RVON-I/O

Release

Notes

The RVON-I/O card once these changes take place will go from 9030-7772-000 Rev A to 9030-7772-000 Rev B.

FIGURE 1. Crosstalk Resistors to Capacitors placement (board number 9030-7772-000).

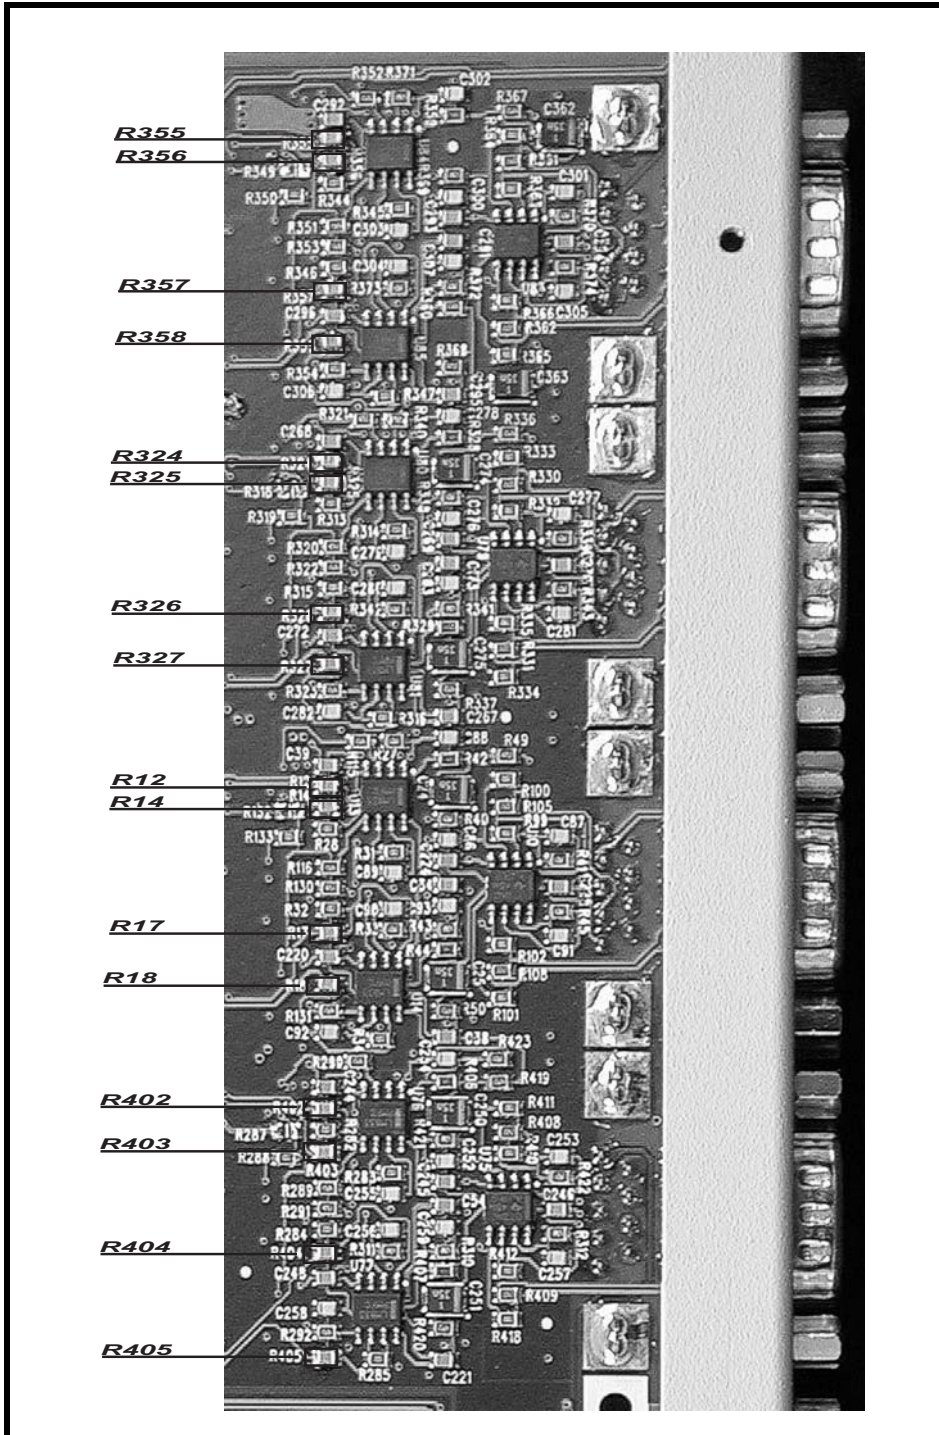
The output to the matrix is being heard on the same channel's input. The input to the Codec need to be AC coupled. To fix the crosstalk on the same channel, you must remove 16 resistors (150Ohm) - **R12, R14, R17, R18, R324 - R327, R355 - R358, R402 - R405** and replace with 16 capacitors (part number **102881-880**, 0.47 uF 16V) in **R12, R14, R17, R18, R324 - R327, R355 - R358, R402 - R405**. For replacement positions, see figure 1.

FIGURE 2. Resistor Placement (board number 9030-7772-000).

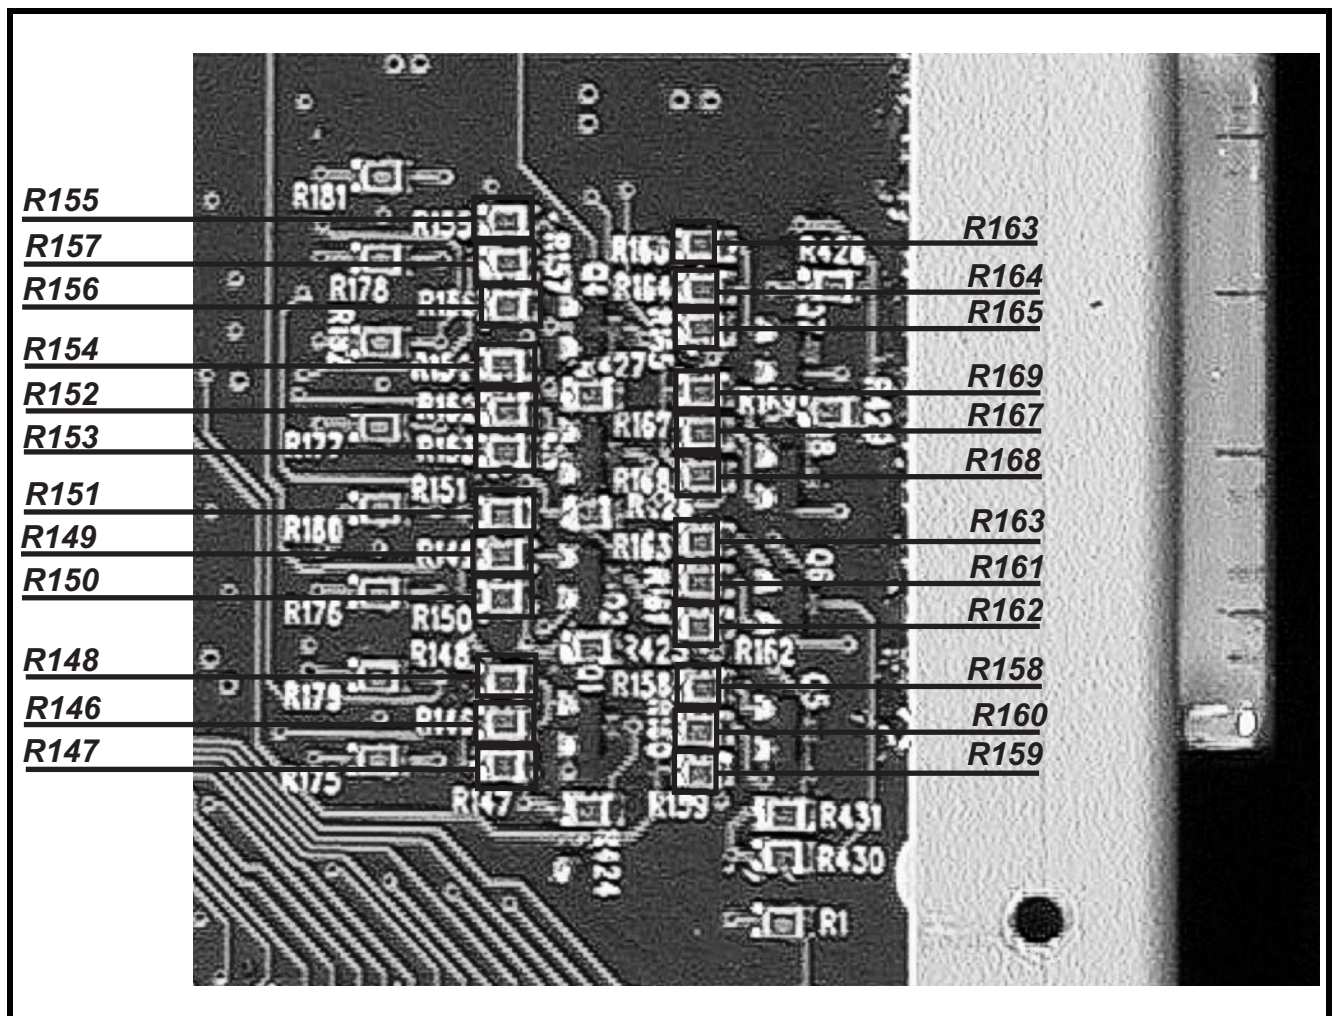
The GPO transistor can't handle the current load for a dual Master Controller chassis. The GPO transistor's input resistors need to be reduced to increase the base current. This will increase the collector current's load.

To fix this issue, change the 3 input resistors of each GPO from 22.1K to 2K. This increases the collector current from ~10 mA to ~60 mA. The transistor can handle 200 mA.

Also, remove 24 resistors, **R146 through R169** and replace them with 2K resistors (part number **102515-229**). See figure 2 for resistor placement.

FIGURE 3. Resistor Changes

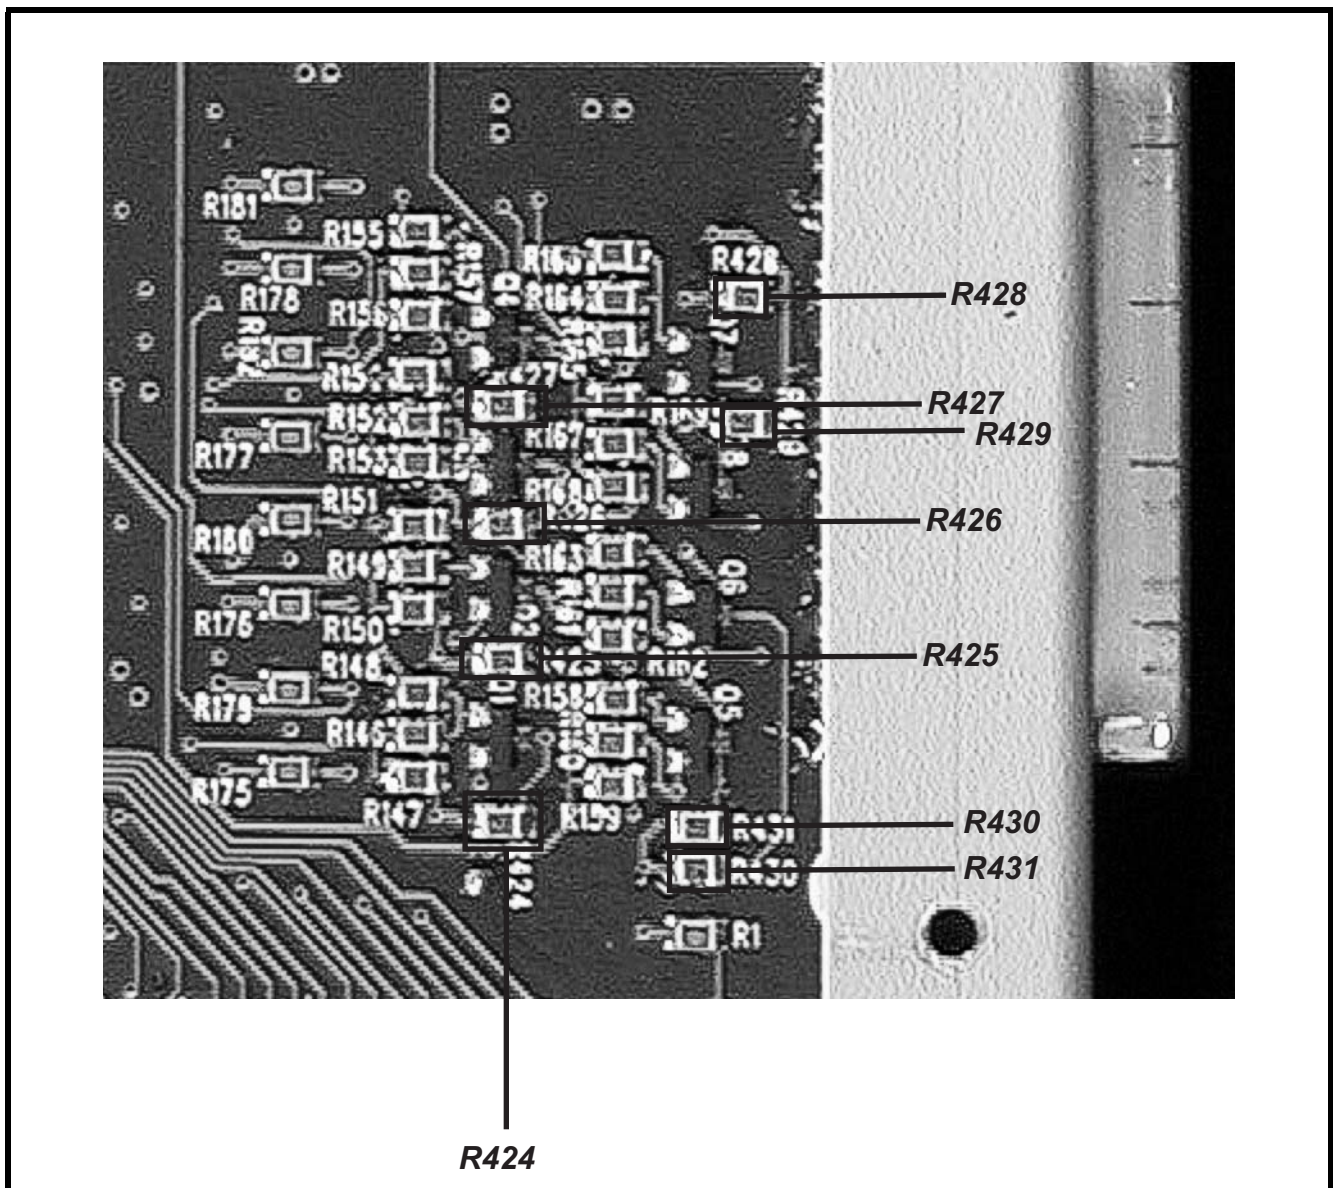
The RVON-I/O's voltage drop across the GPO output resistor is too large for the Cronus photo coupler GPI. The Cronus series resistor to the photo-coupler is also too large. The voltage drops across both resistors prohibit operation.

To fix this issue, change the RVON-I/O GPO Output from 22.1K to 6.19 K on the RVON-I/O card and replace four resistors (R11 through R14) from 3 K to 470 Ohms.

1. On the RVON-I/O card, remove 8 resistors (**R424 through R431**) and replace with 6.19 K resistors (part number **102515-276**). See figure 3 for resistor placement.
